**STAFF REPORT: 10/08/2025 MEETING**

**ADDRESS: 1760 VAN DYKE**

**APPLICATION NO: HDC2025-00522**

**SCOPE: INSTALL VINYL SIDING; INSTALL VINYL WINDOWS**

**Front façade. Areas outlined in red show deteriorated faux brick/asphalt siding Photo taken on 9/22/2025 by HDC staff**

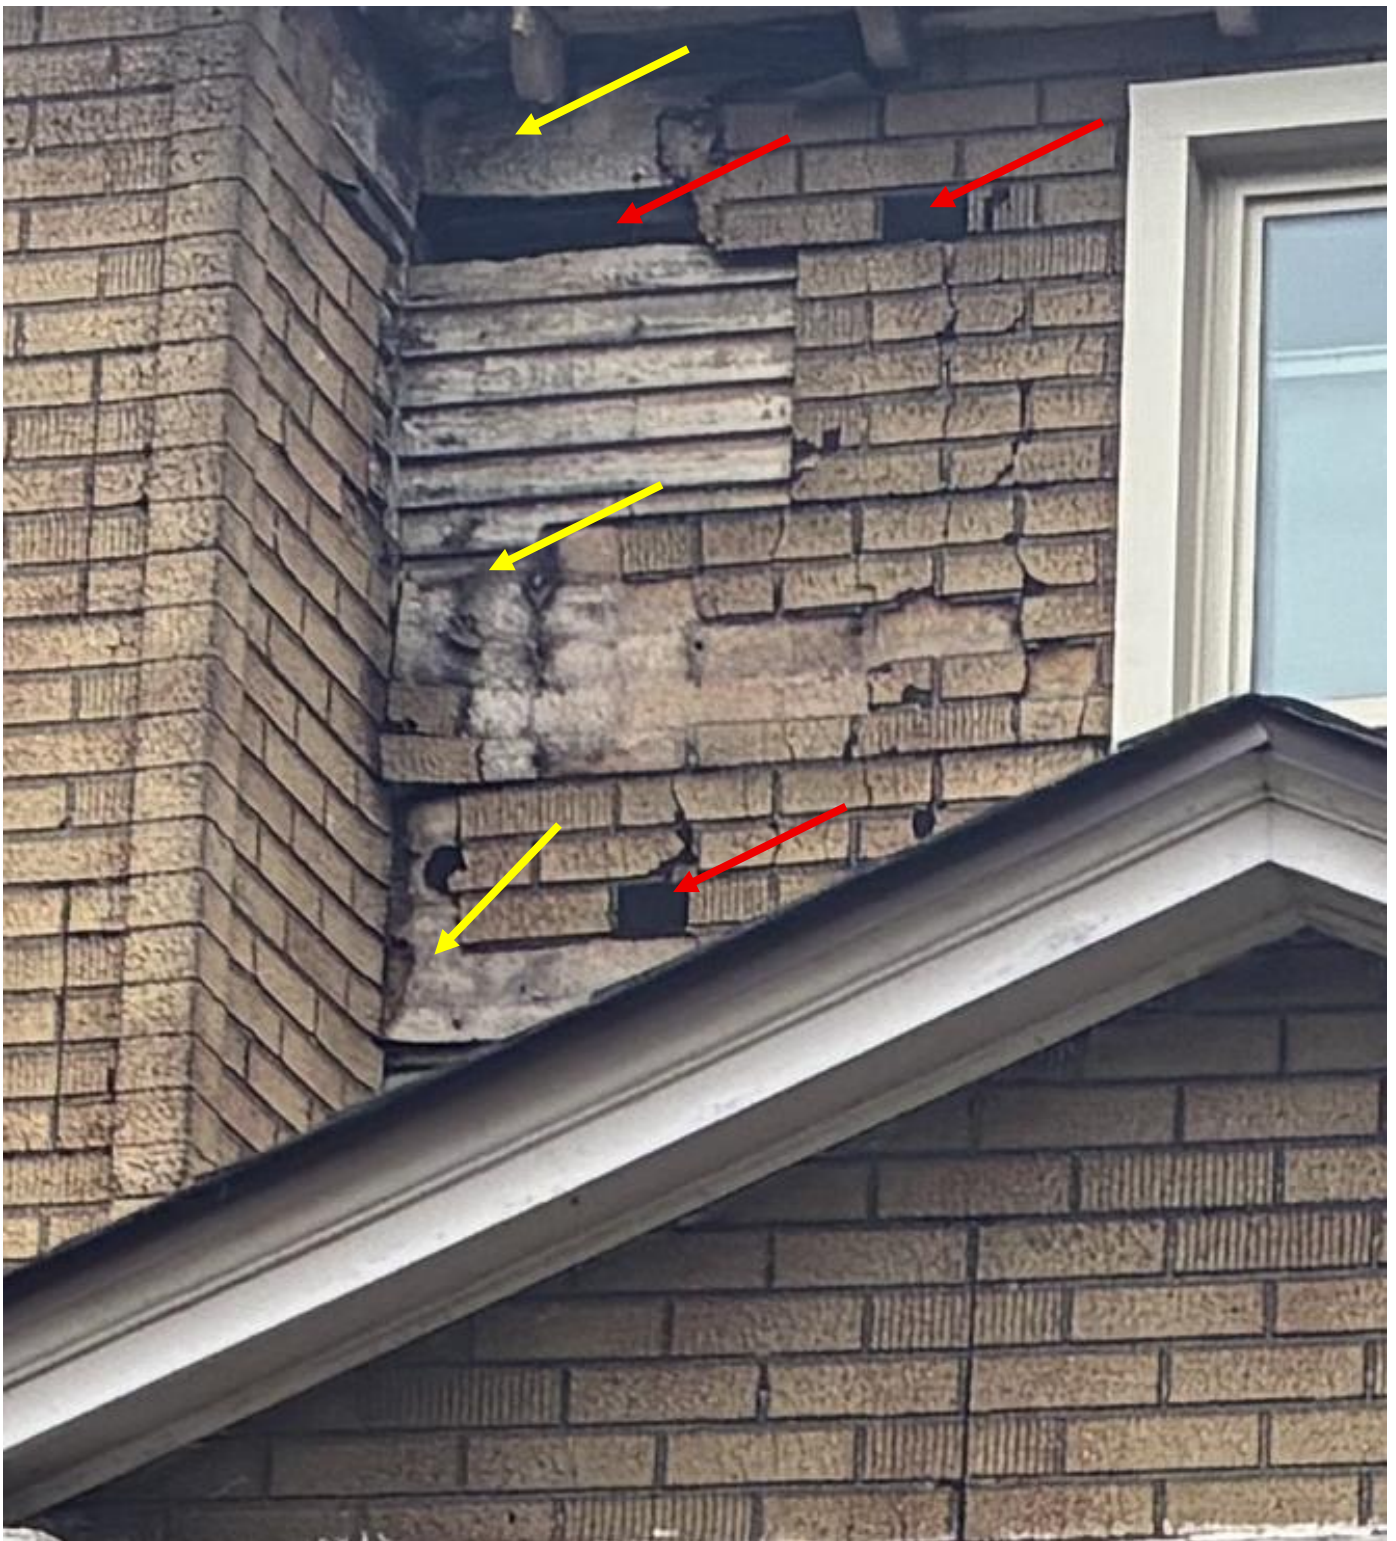
See the below pictures of the areas of the deteriorated faux brick/asphalt siding. Note the areas where the siding has fallen off completely, leaving the historic lapped wood siding fully visible, and the areas where the outermost surface of the siding has peeled away, leaving the fiberboard and or tarpaper beneath (the black and light brown areas) visible. Note that the black

areas on the wall do not appear to be “holes” where the original wood siding has rotted away from the wall.

- Please note that the current proposal has not provided evidence that the historic lapped wood siding that remains underneath the existing faux brick/asphalt/Insulbrick siding is deteriorated to an extent that merits its wholesale removal. Staff does have the authority to approve proposals for the removal of faux brick/asphalt/Insulbrick siding and repair the remaining historic siding underneath, so it is possible for the applicant to undertake a removal of the

It is therefore staff's opinion that retaining and repairing the original siding, if possible, is the most appropriate treatment for the siding at this property, will greatly enhance the building's historic character, and further restore historic character to the West Village Historic District. If the wood siding beneath is deteriorated beyond repair, then new wood siding which matches the existing should be installed.
